Conceptual Review Agenda

Schedule for 11/16/15 to 11/16/15

Monday, November 16, 2015

300 Boardwalk Dr Office

Landings Office Building			Conceptual Site Plan		
No.	Description	Date	Project number	2015-23	ARCH-3
			Date	10/1/2015	
			Drawn by	SA	
			Checked by	MR	
			Scale	1" = 50'-0"

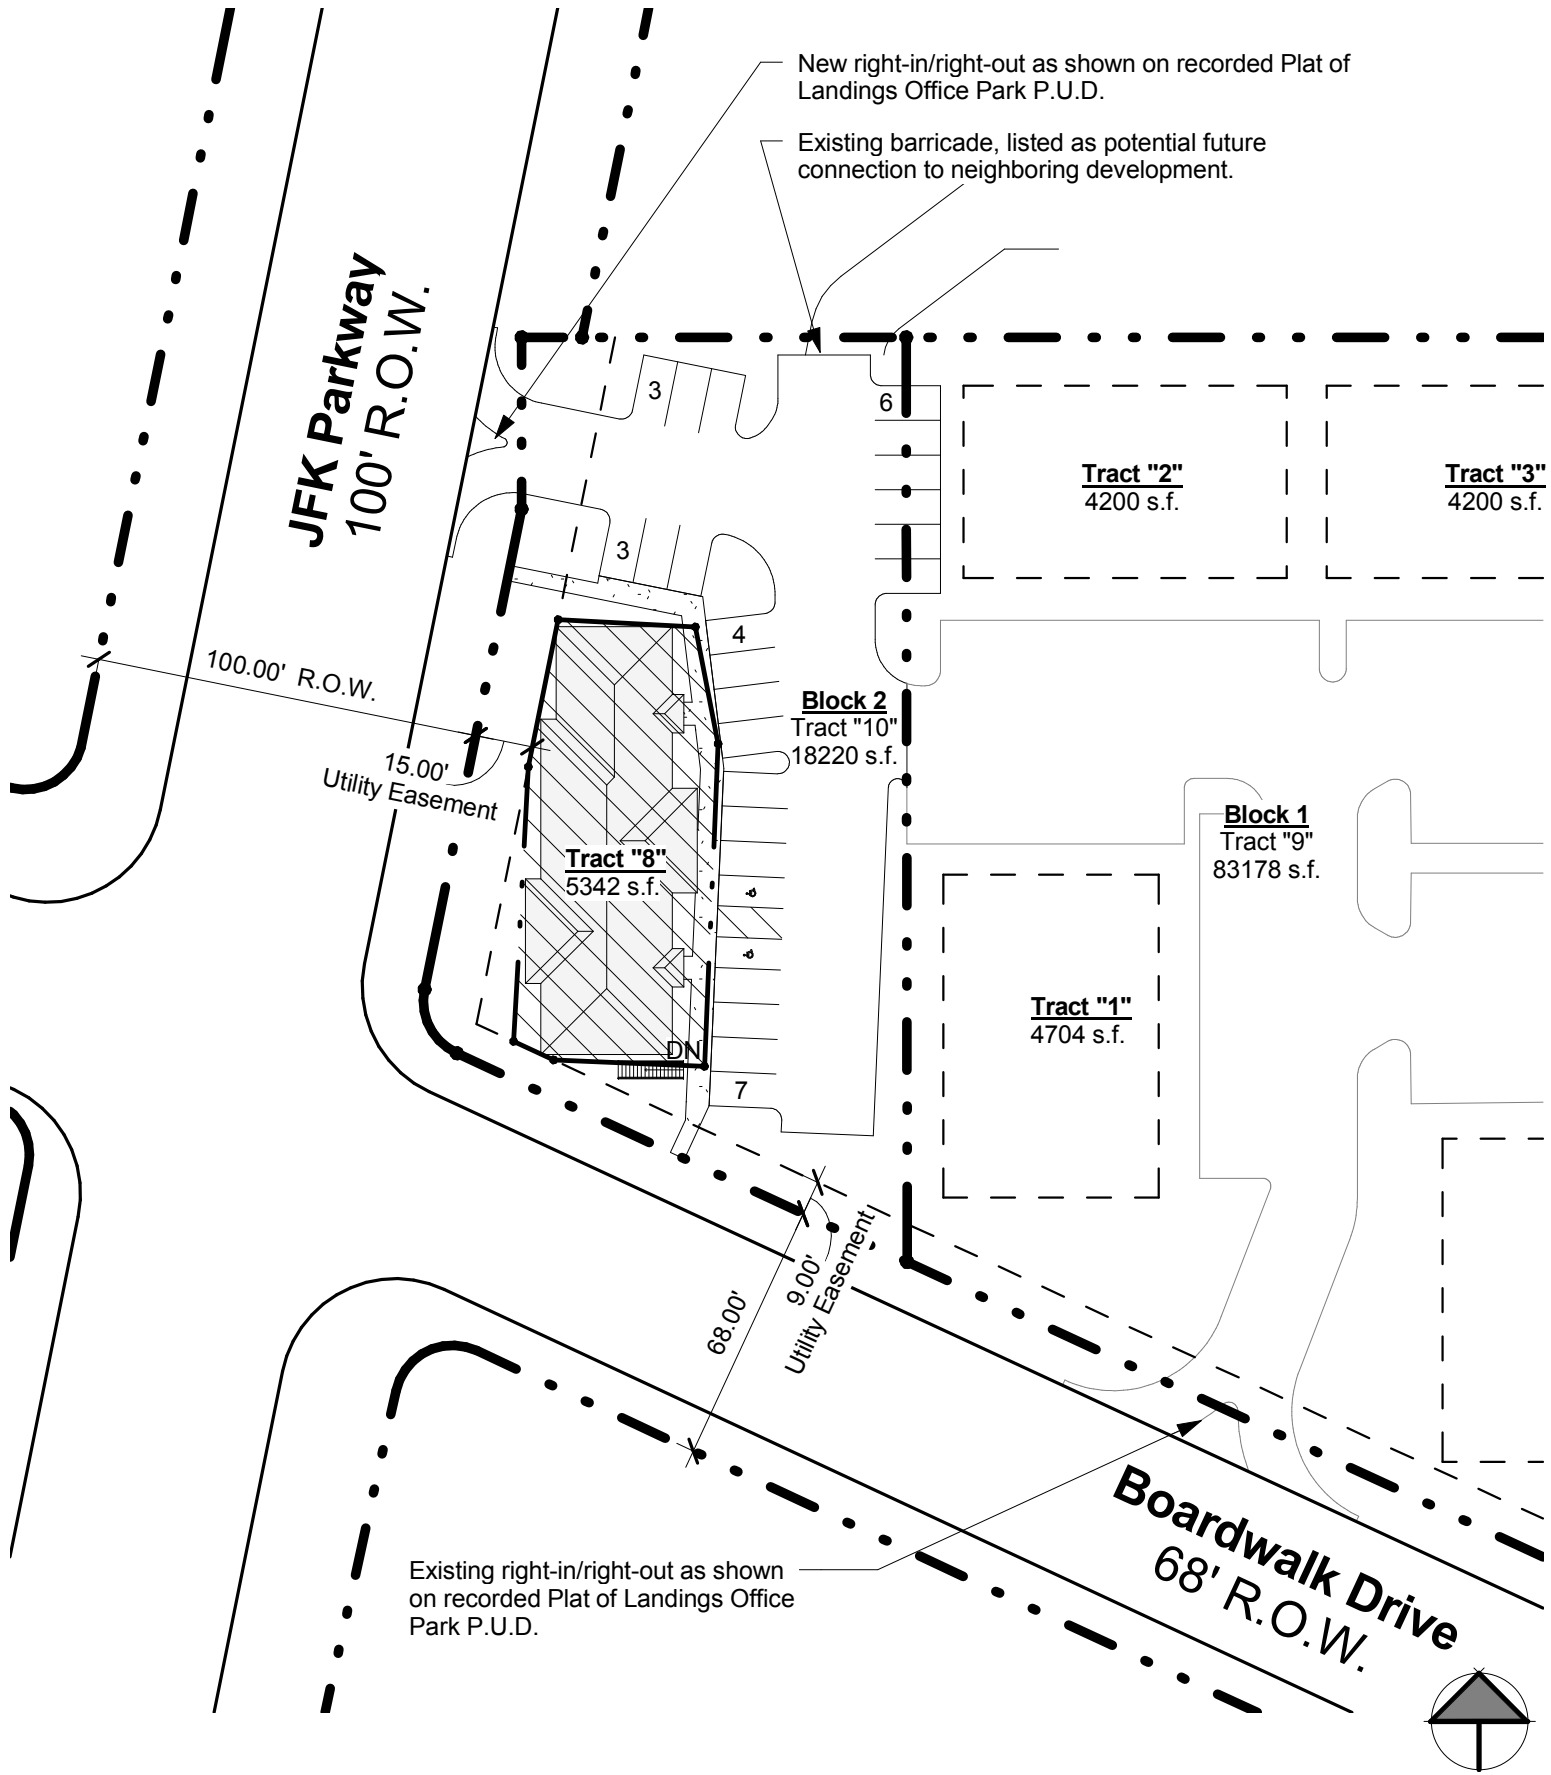
3. The proposed parking lots exceeds the maximum parking allowed per Land Use Code section 3.2.2(K)(2). The maximum parking allowed is 19 spaces while the proposal shows 25. You will need to either seek a modification to this standard or pursue an exception to the general office parking standard as outlined in Land Use Code section 3.2.2(K)(4).

4. Please submit a lighting plan in accordance to Land Use Code section 3.2.4.
5. The site plan does not show a trash and recycling enclosure. Will you be sharing an enclosure with an adjacent development? Please note this when you submit your PDP.
